PLAN COMMISSION

April 10, 2023 5:30 p.m.
Council Chambers, Room #115
Hybrid Zoom Link:

**BLOOMINGTON PLAN COMMISSION
STAFF REPORT**
Location: 617 N Madison St / 422 W 10th St

**BLOOMINGTON PLAN COMMISSION
STAFF REPORT**

Original Layout

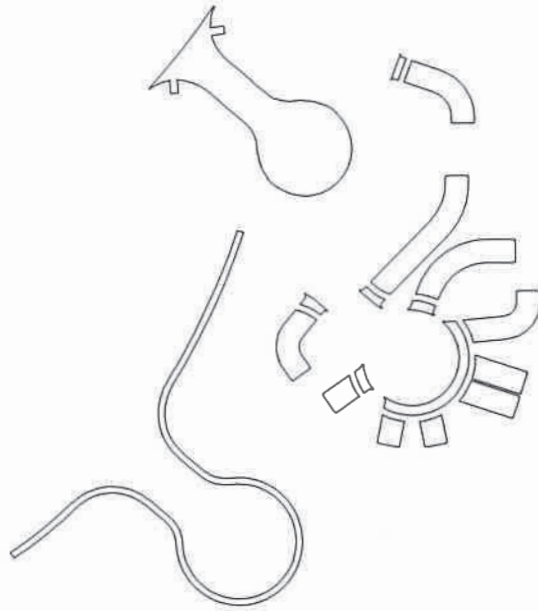
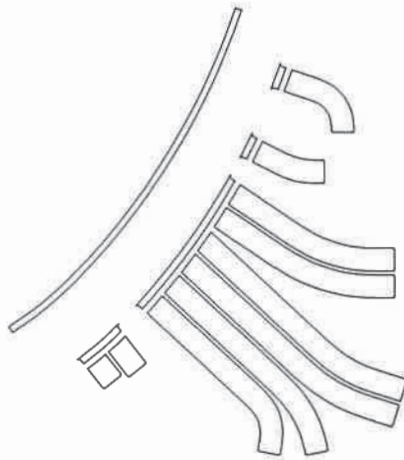
CHANGES SINCE DECEMBER 2022 HEARING: The petitioner is proposing to remove the pedestrian connection on the southeast portion of the site to Bloomington High School North to the south, after consultation with the School Corporation. The Department is amenable to this change, as the topography in the previously approved location is quite steep.

The issue of required subdivision waivers was discussed extensively at the last hearing. As a reminder, the petitioner received PUD Final Plan and Primary (Preliminary) Plat approval for Section V in 2008 with case number PUD-47-07. The petitioner did not go forward with building the entirety of Section V. Though the petitioner made changes to the design from PUD-47-07, such as number and location of lots and location of the tree preservation easement, the petitioner did not want to change or amend the non-compliant road design. The Plan Commission asked to see a drawing of code-compliant road design. The petitioner submitted a conceptual site plan showing alternative vehicular access design for parcels in the southwest and southeast corners of the petition site. In the southwest corner, the eyebrow was removed, and a shared driveway is proposed for lots 41, 42, and 35. In the southeast corner, the cul-de-sac was removed, and each unit was given a separate driveway. The conceptual design contains the same number of dwelling units as the design that contains the eyebrow and cul-de-sac. The petitioner continues to request the original design, which requires subdivision waivers to be approved, as neither eyebrows nor culs-de-sac are allowed by the Unified Development Ordinance. The Department recommends that the subdivision waivers not be approved, and that the alternative design submitted by the petitioner should be approved, with a limit on the number of driveways, as shown in the attached exhibit.
